From: [Early, Shane \(DNR\)](#)
To: [Jeremiah Cromie](#)
Cc: [KELLER, ERIC \(DNR\)](#); [MAUNEY, MARTY \(DNR\)](#); [YOUNG, BRENDA \(DNR\)](#)
Subject: RE: SE-21-00015 Werner -Notice of Application
Date: Thursday, July 29, 2021 11:18:30 AM
Attachments: [image001.png](#)

RE: SE-21-00015 Werner

SEPA Application Comments

FIGURE R403.1.7.1
FOUNDATION CLEARANCE FROM SLOPES

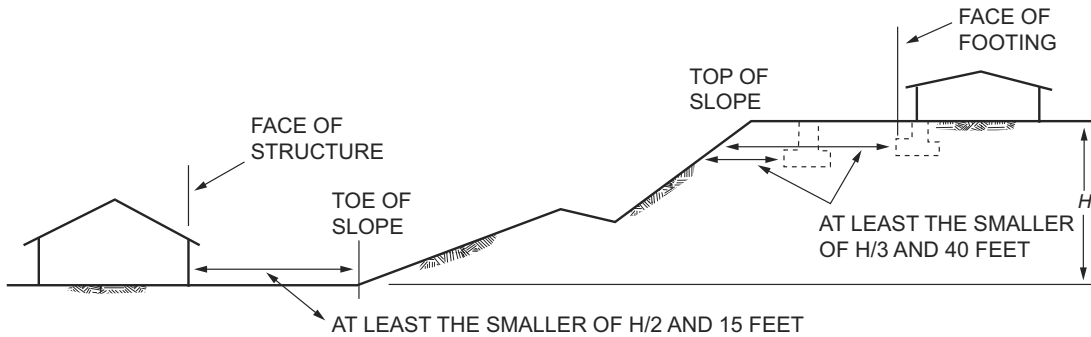
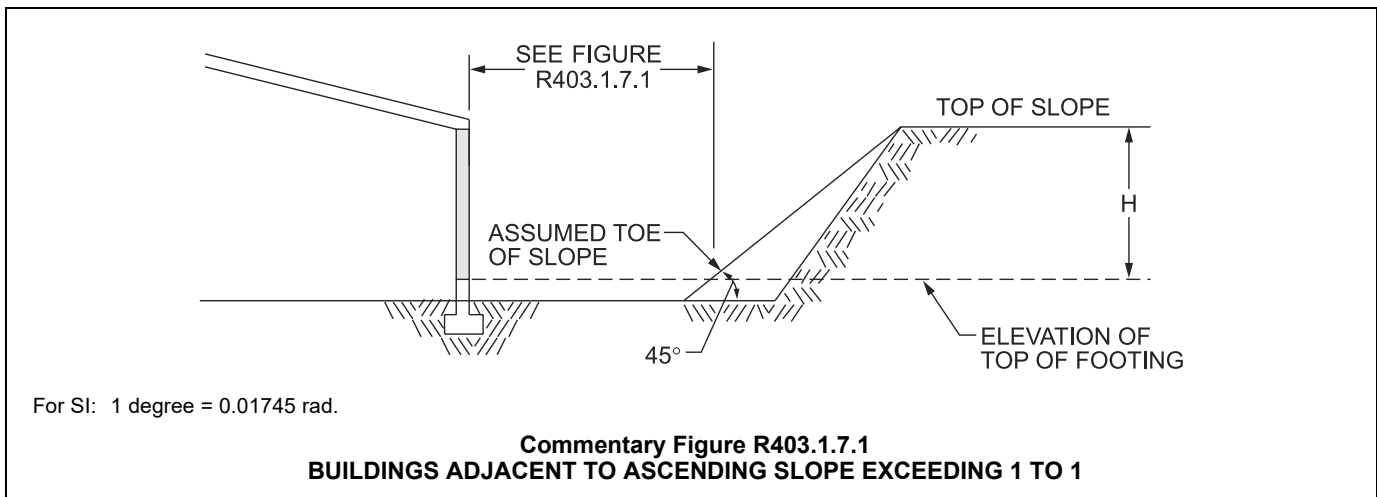
1. All future construction of buildings and other structures shall conform to Kittitas County Code Title 14 and the International Building and Fire Codes adopted at the time of building permit submittal. This includes fire suppression and fire separations as well as setbacks to slopes and structures on engineered fill.
2. Retaining walls over 4 feet in height require a building permit.
3. Setbacks to slopes per IRC R403.1.7 (attached).

R403.1.7.1 Building clearances from ascending slopes. In general, buildings below slopes shall be set a sufficient distance from the slope to provide protection from slope drainage, erosion and shallow failures. Except as provided in Section R403.1.7.4 and Figure R403.1.7.1, the following criteria will be assumed to provide this protection. Where the existing slope is steeper than one unit vertical in one unit horizontal (100-percent slope), the toe of the slope shall be assumed to be at the intersection of a horizontal plane drawn from the top of the foundation and a plane drawn tangent to the slope at an angle of 45 degrees (0.79 rad) to the horizontal. Where a retaining wall is constructed at the toe of the slope, the height of the slope shall be measured from the top of the wall to the top of the slope.

R403.1.7.2 Footing setback from descending slope surfaces. Footings on or adjacent to slope surfaces shall be founded in material with an embedment and setback from the slope surface sufficient to provide vertical and lateral support for the footing without detrimental settlement. Except as provided for in Section R403.1.7.4 and Figure R403.1.7.1, the following setback is deemed adequate to meet the criteria. Where the slope is steeper than one unit vertical in one unit horizontal (100-percent slope), the required setback shall be measured from an imaginary plane 45 degrees (0.79 rad) to the horizontal, projected upward from the toe of the slope.
